BOLINGBROKE JSP 17-34

Public hearing at the request of Singh Development, LLC for approval of Preliminary Site Plan, Site Condominium, Woodland Permit, and Stormwater Management Plan. The subject property is located in Section 10 at the intersection of Novi and Old Novi Roads, north of 12½ Mile Road and is zoned R-4, **One Family Residential**. The applicant is proposing to develop the 19.78 acre parcel to 46 single-family, detached residential site condominiums.

PLAN REVIEW CENTER REPORT

Review Date: April 19, 2017
Review Type: Preliminary/Final Site Plan
Project Name: JSP17-34 Bolingbroke
Plan Date: 3-30-2017
Prepared by: Kirsten Mellem, Planner
Contact: **E-mail:** kmellem@cityofnovi.org **Phone:** 248-347-0484

LS-1 of 7

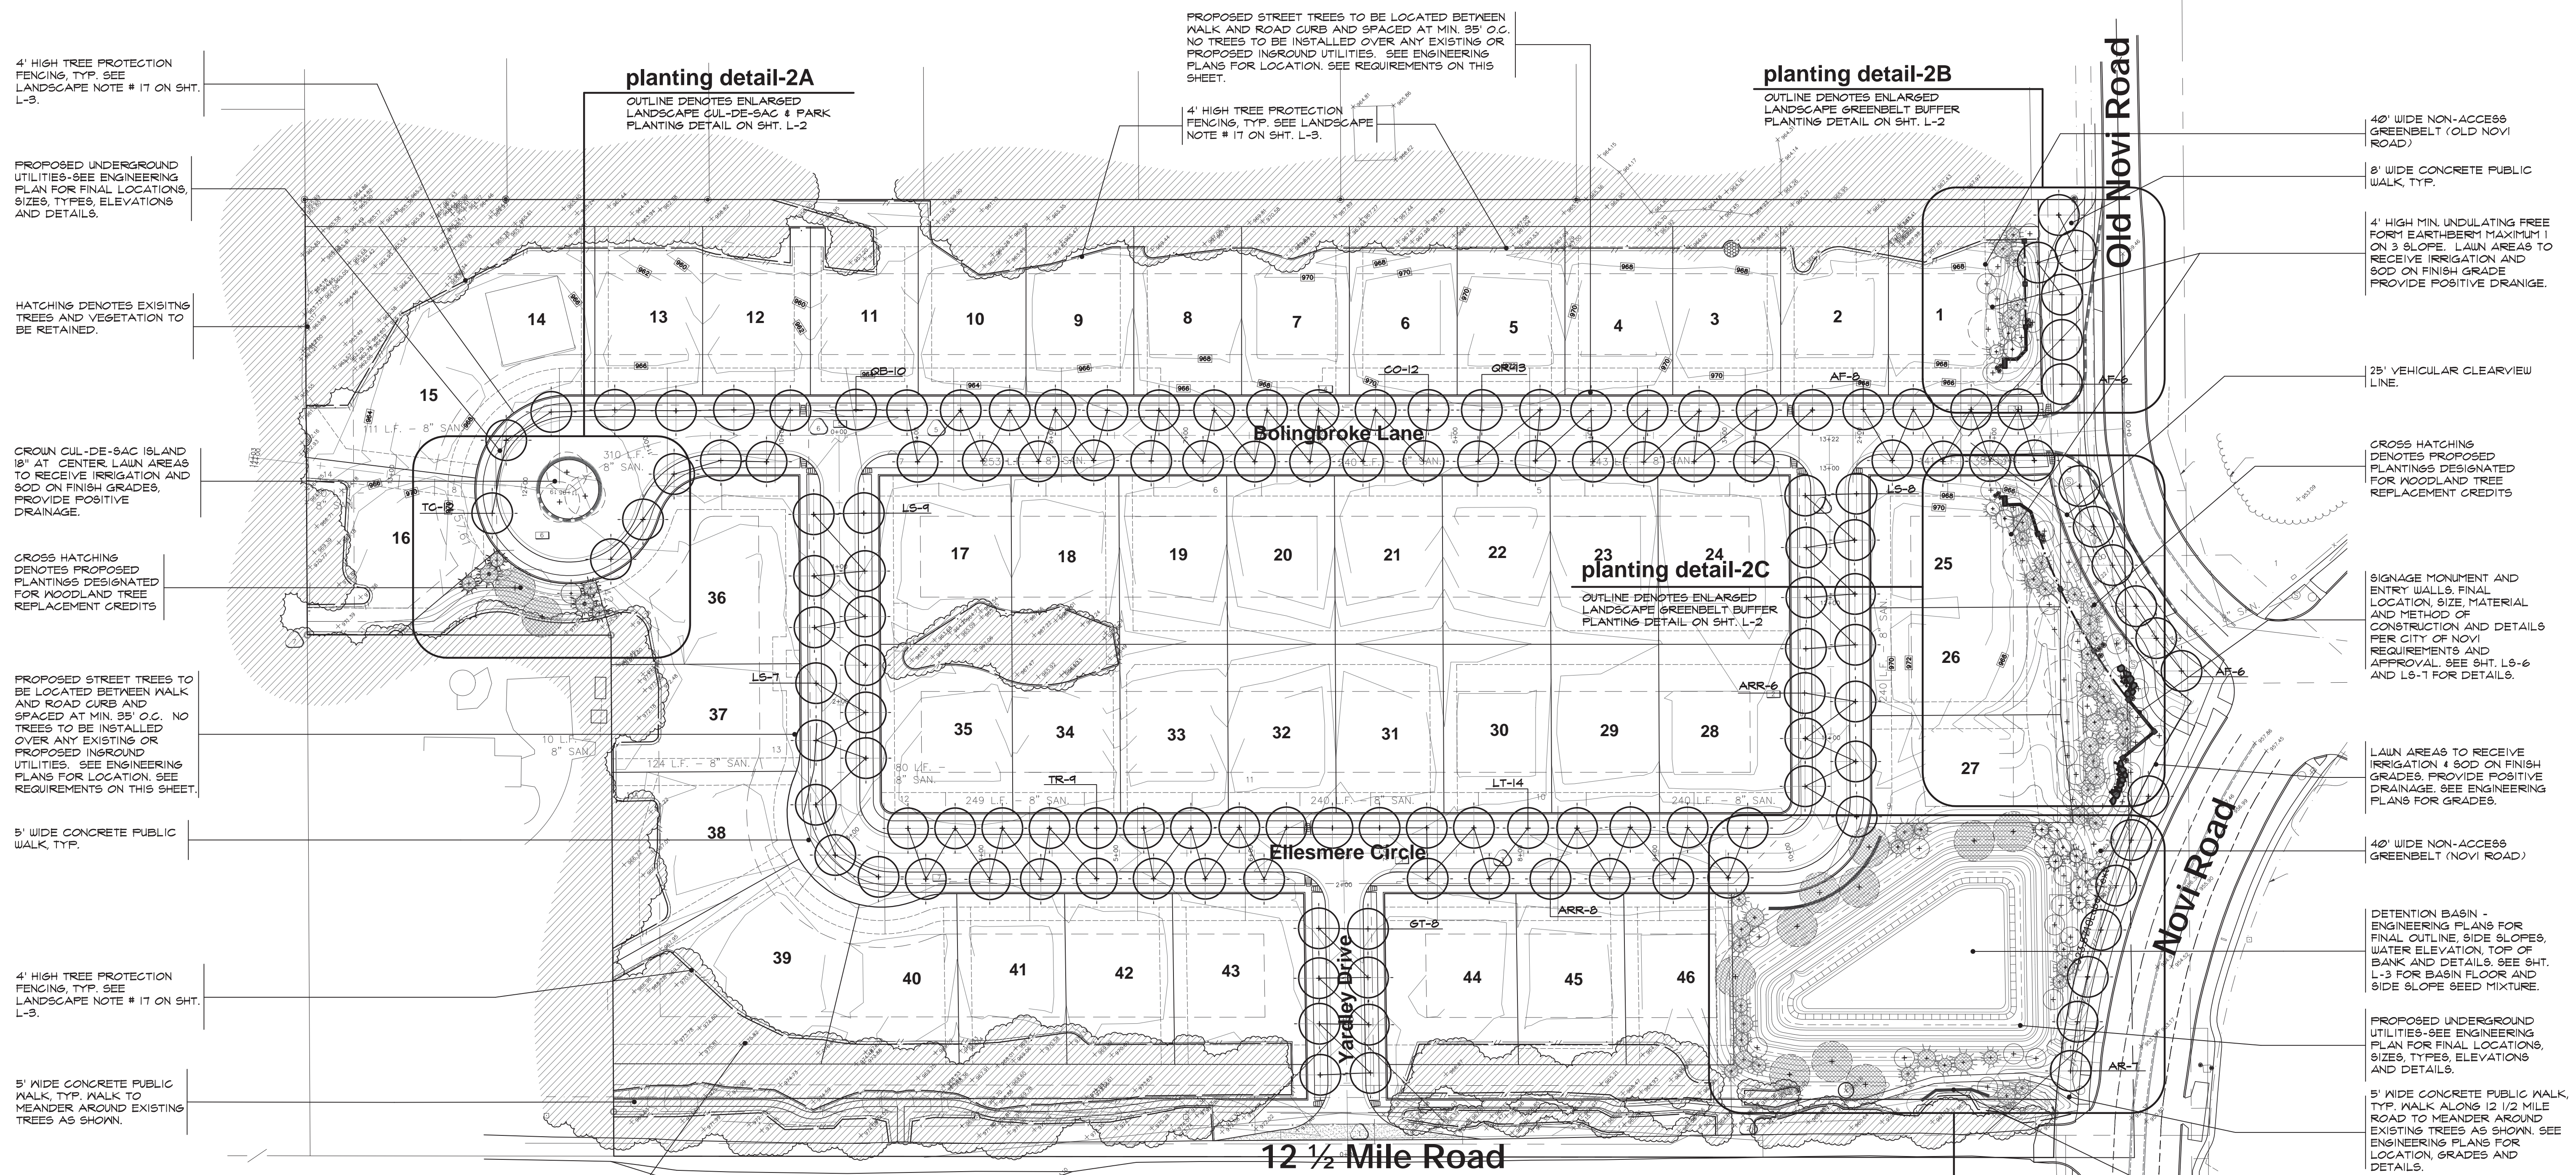
1. Proposed utility lines are provided.
2. **Please clearly show all overhead utility lines, fire hydrants and utility structures on the landscape plan.**

4. Lots – Based on the lots' frontages, 114 street trees are required, and 120 are provided.
5. The clear vision zones called for in Section 5.9 should be provided for all street intersections, including interior intersections. Trees cannot be placed within those zones. If the required number of street trees cannot be located along the roads because of these clear vision zones, the applicant may request a landscape waiver for the trees that can't be planted for this reason. **The waiver should be included in the list mentioned above.**

1. **Please revise the details provided per the instructions on the landscape chart.**
2. **Please add a tree guy and tree protection fence detail.**

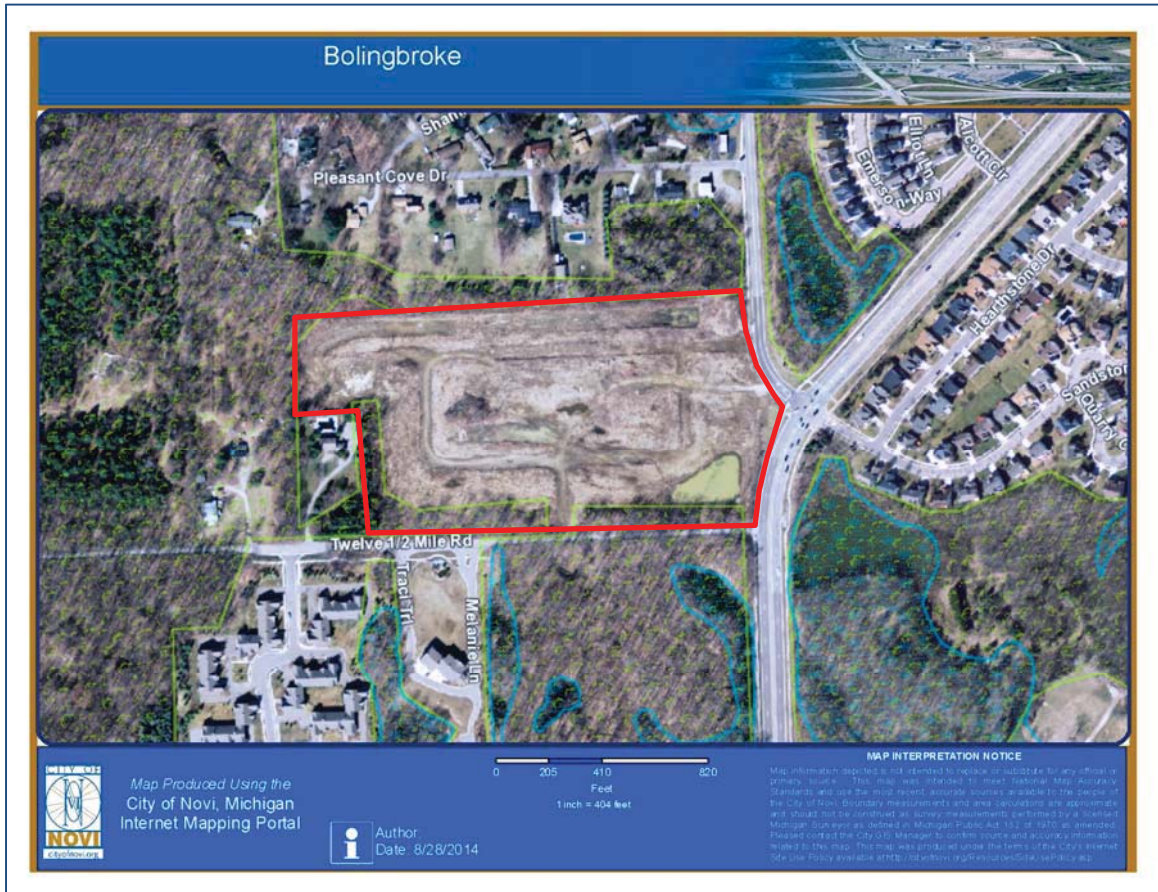
The proposed project site contains a small portion of City-Regulated wetland along the northern boundary of the proposed site that is not shown on the City of Novi Wetland and Woodland Map (Figure 1). The area of flagged wetland is located north of proposed Lots 2, 3, and 4 (see Figure 2). The on-site wetland was delineated by King & MacGregor, Environmental, Inc. (KME).

Figure 1. City of Novi Regulated Wetland & Woodland GIS Coverage Map (approximate property boundary shown in red). Regulated Woodland areas are shown in green and regulated Wetland areas are shown in blue). Approximate project boundary is indicated in red.

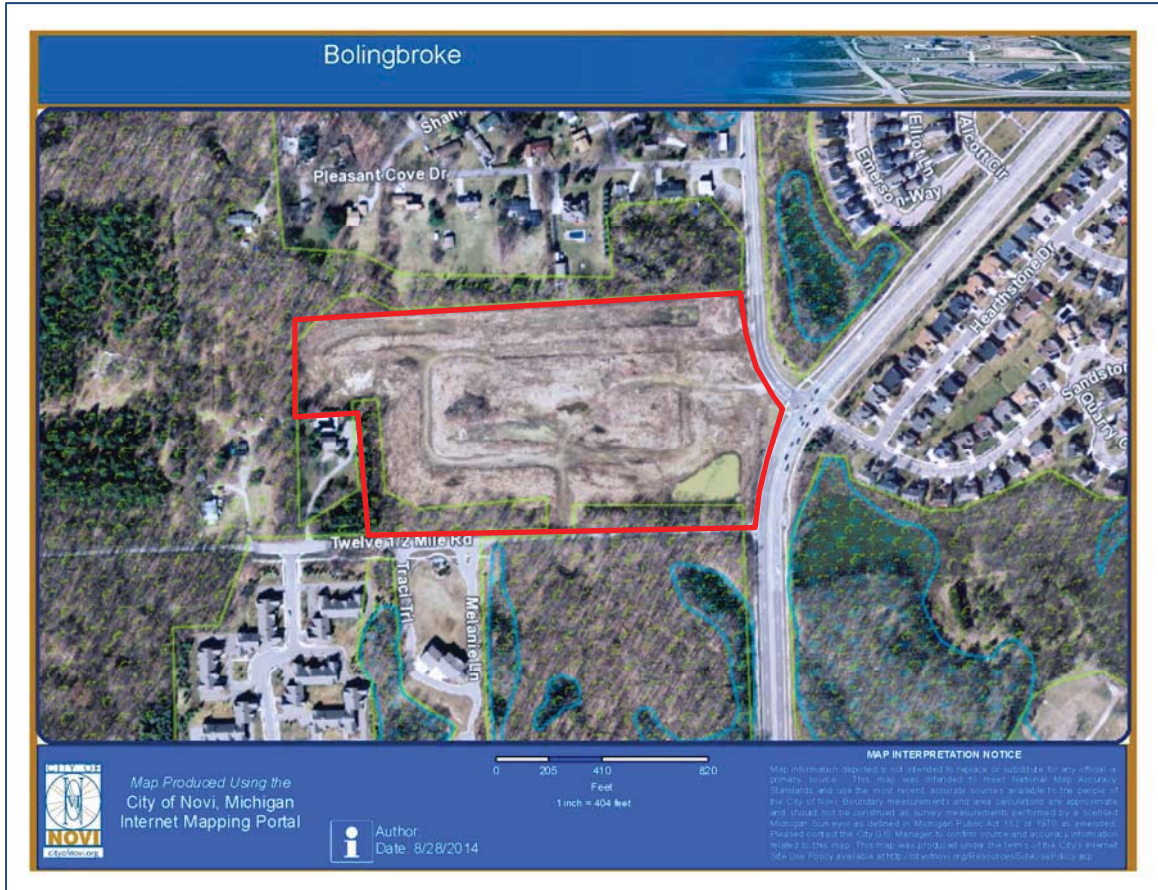
Based on ECT's in-office review of available materials including the City of Novi Regulated Woodland map (see Figure 1) and historical aerial photographs, it appears as if the overall proposed project site contains several areas of City-regulated woodlands. Although the majority of this site has been previously cleared to prepare for development, several areas of regulated trees remain on-site.
